**VENTURA UNIFIED SCHOOL DISTRICT
BUENA HIGH SCHOOL STADIUM SURFACING**

BID # E15-25

ADDENDUM #01

Bid Addendum No. A
To the contract documents for BUENA HIGH SCHOOL TRACK AND FIELD REPLACEMENT
For the VENTURA UNIFIED SCHOOL DISTRICT

L2.01

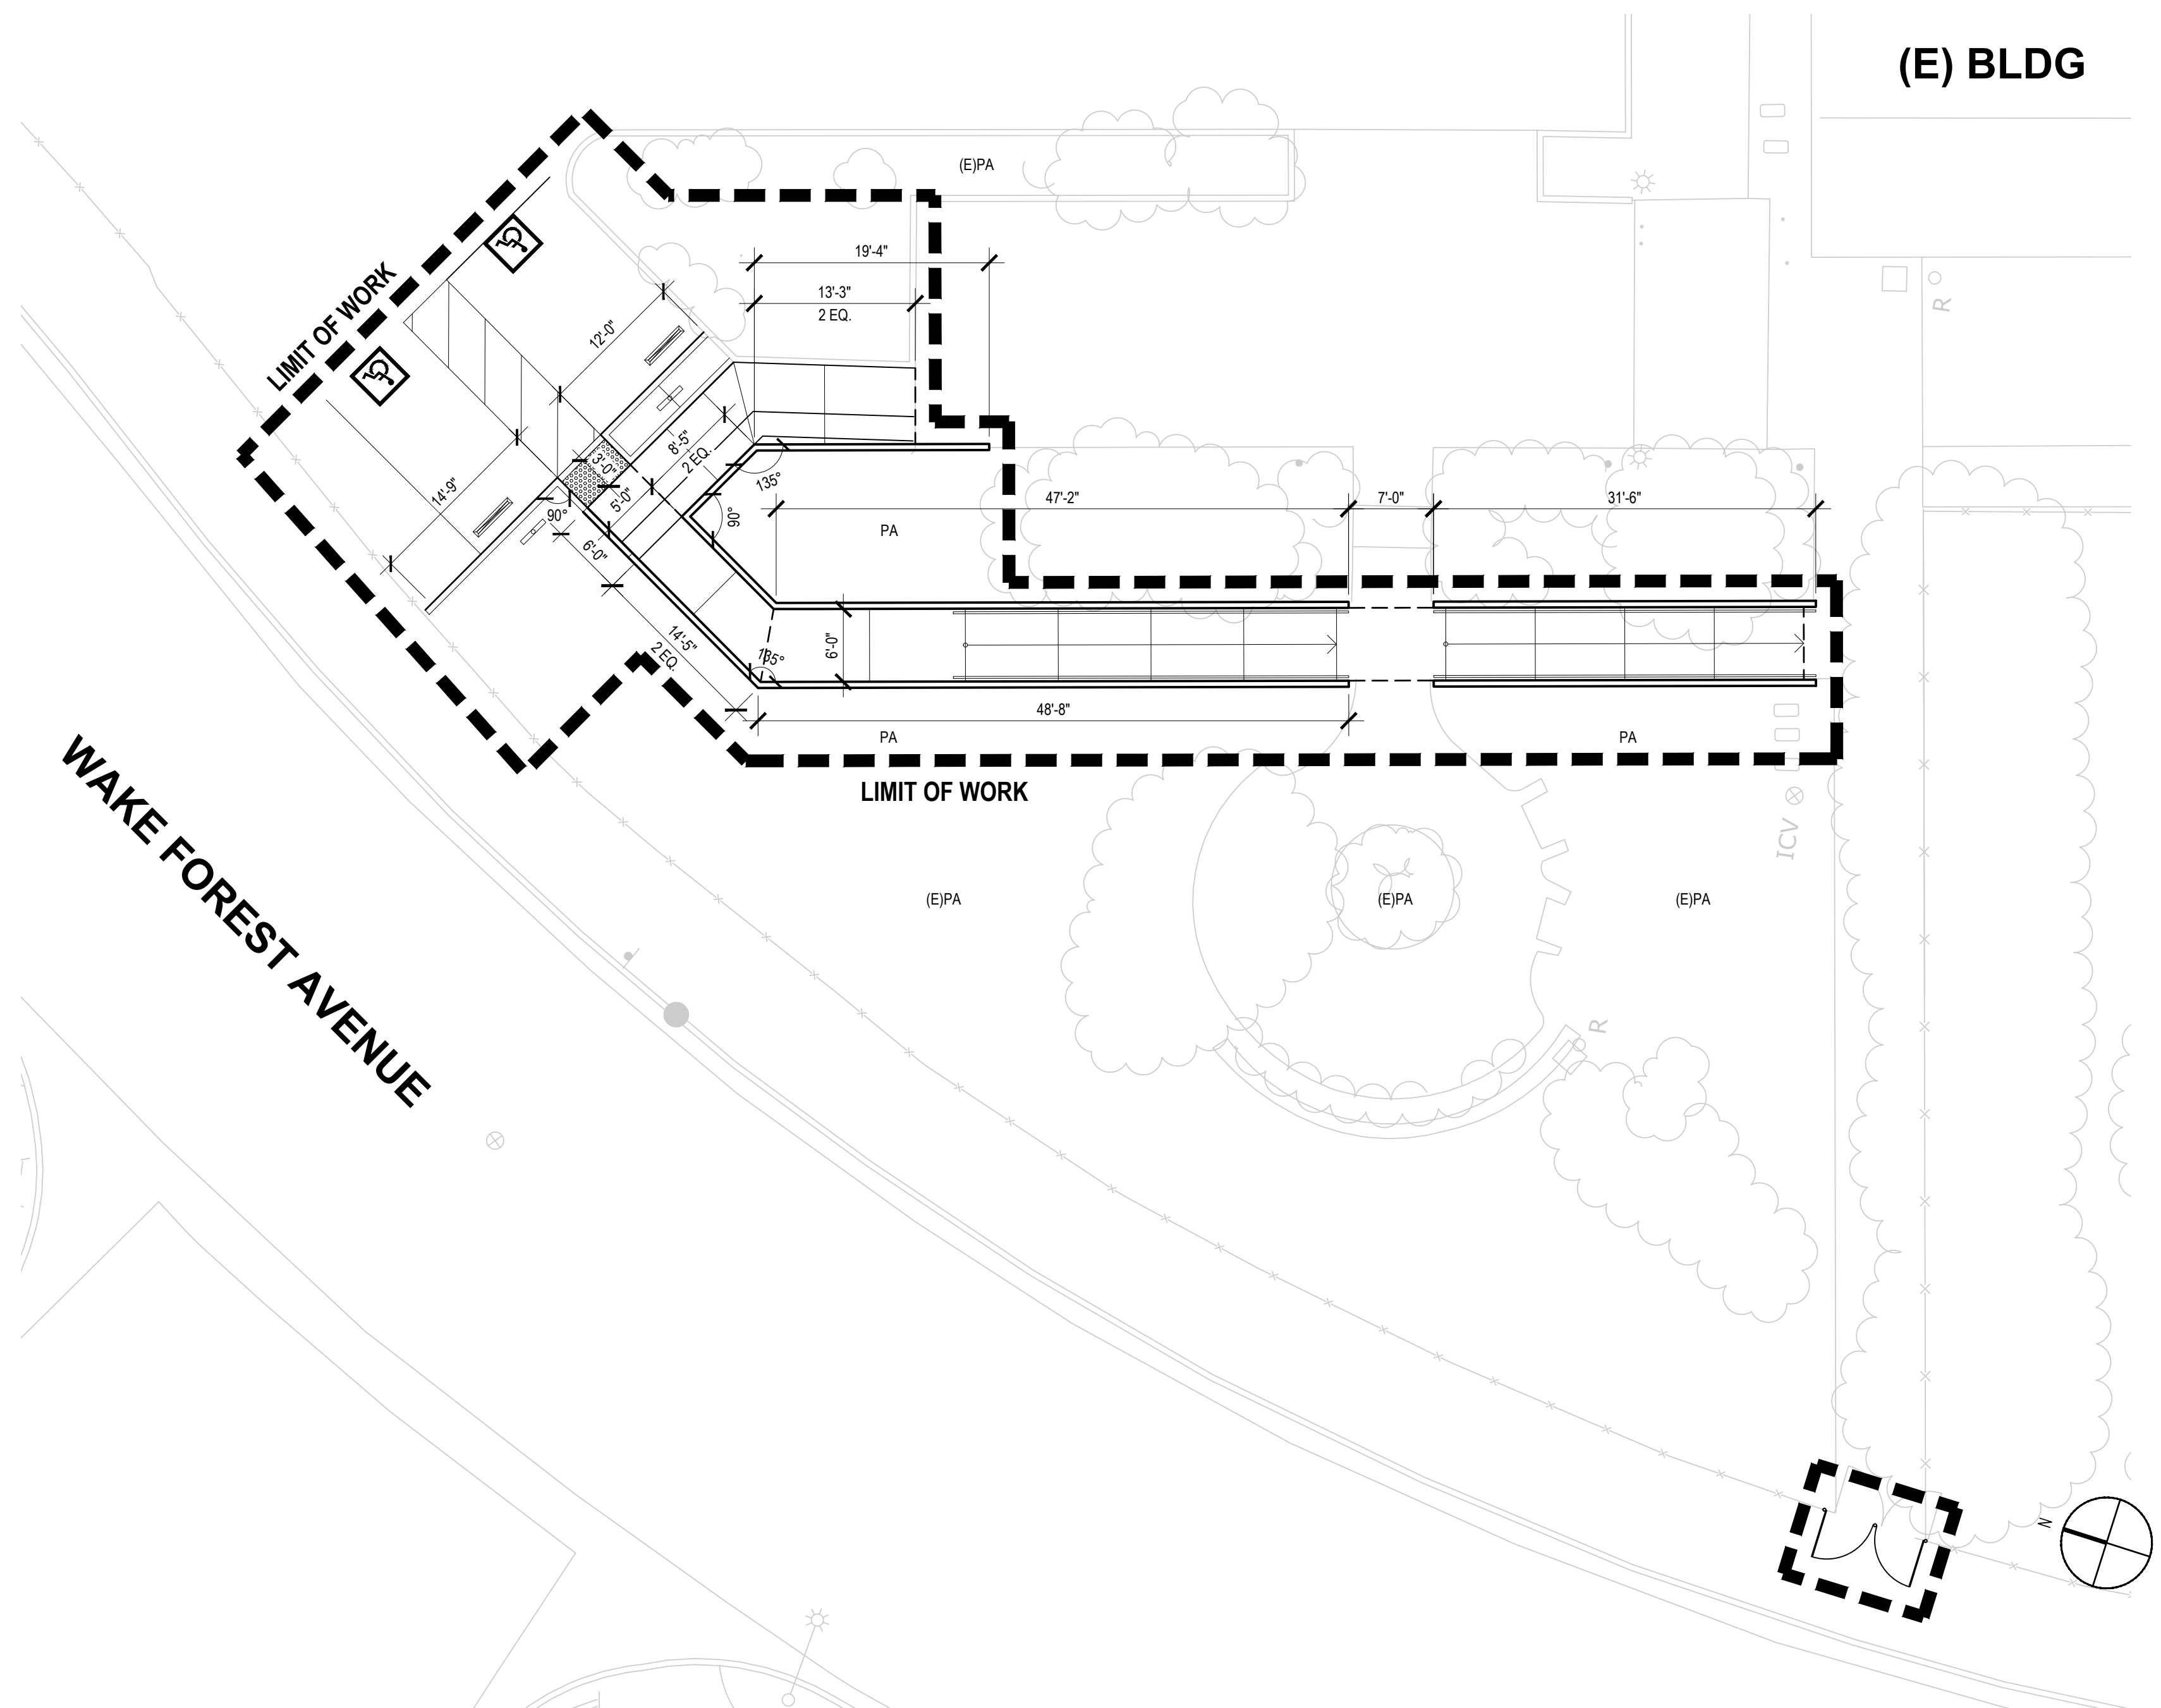
- Item No. 5** **L1.02 MATERIALS PLAN** - Materials Keynote Legend Updated. Keynotes A09 & A10 detail reference updated. Reference keynote O added.
- Item No. 6** **L2.01 LAYOUT PLAN** – Due to added Com box; dimensions updated accordingly.

23

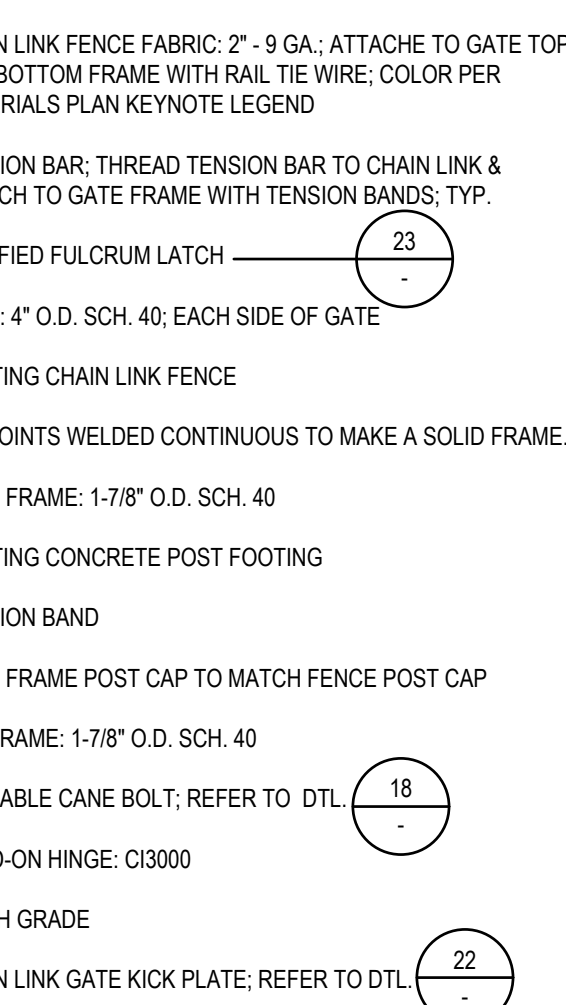
Q#2: WE RESPECTFULLY ASK TO CONFIRM THAT THIS LOCATION HAS A UNIQUE CIRCUMSTANCE REQUIRING THE MODIFIED FULCRUM LATCH PER DETAIL 23/SH. L5.02 IN PLACE OF THE "ROLO LATCH" TYPICAL TO OTHER DISTRICT CAMPUSES AND FACILITIES.

Plan Sheet L5.02 includes CONSTRUCTION DETAIL 23: MODIFIED FULCRUM LATCH. Fence Factory's experience with prior Double Swing Gate installations for the Ventura Unified School District called for a "Rolo Latch".

We respectfully ask to confirm that this location has a unique circumstance requiring the Modified Fulcrum Latch per Detail 23/Sh. L5.02 in place of the "Rolo Latch" typical to other District campuses and facilities.

A#2: FULCRUM LATCH IS REQUIRED PER ADA; CONSTRUCT FULCRUM LATCH PER PLAN.

FULCRUM LATCH IS REQUIRED PER ADA; CONSTRUCT
FULCRUM LATCH PER PLAN.

L5.02

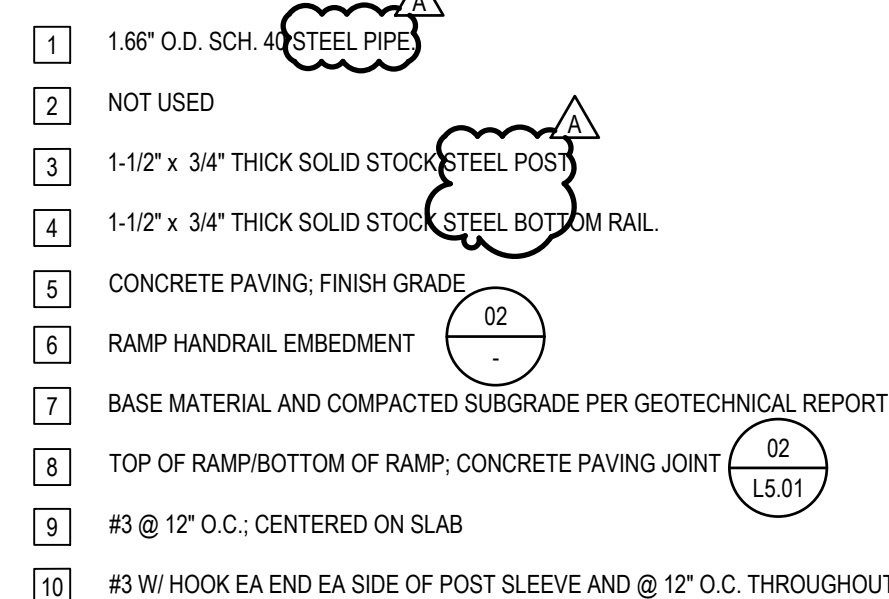
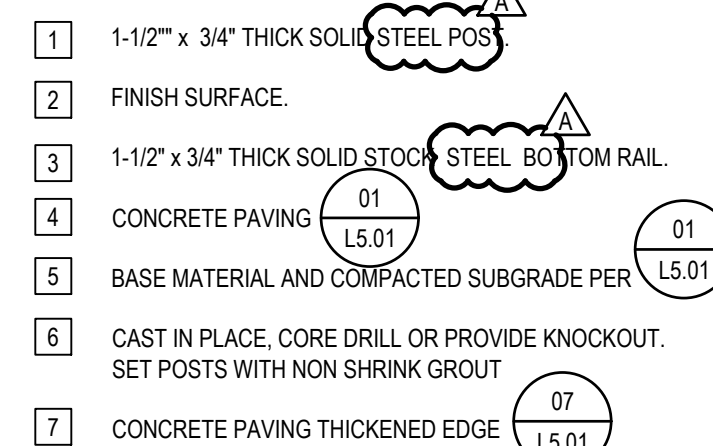
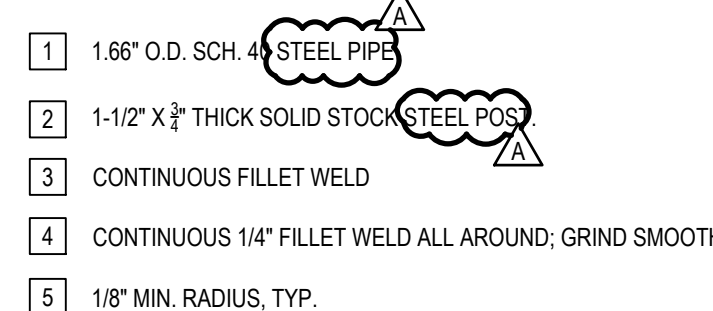
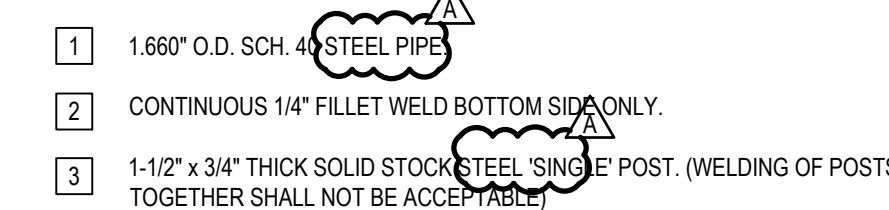
- Item No. 9** **L5.02 CONSTRUCTION DETAILS** – Details 01, 02, 03, & 07 have been revised removing any reference to ‘Stainless Steel’.
- Item No. 10** **L5.03 CONSTRUCTION DETAILS** – Detail 08, keynote 10 updated.

Plan Sheet L5.02 CONSTRUCTION DETAILS (01, 02, 03 and 07 specific to Handrail) include detailed references to Stainless Steel: Tube, Posts and Bottom Rail. Sh. L5.02 NOTES: Note "A" reads: "ALL COMPONENTS TO BE STAINLESS STEEL, SEE SPECS." Note "D" reads: "COLD GALVANIZE ALL FIELD WELDS"

Our understanding is Cold Galvanizing over Stainless Steel is not a standard practice:

PLEASE CLARIFY THE TYPE OF MATERIAL REQUIRED FOR THE PIPE AND TUBE RAILINGS FOR THE BUENA HIGH SCHOOL STADIUM SURFACING PROJECT.

A#1: ALL RAILINGS TO BE GALVANIZED. ADDITIONAL INFORMATION PROVIDED IN SPEC SECTION 055213.

ALL RAILINGS TO BE GALVANIZED. ADDITIONAL
INFORMATION PROVIDED IN SPEC SECTION 055213
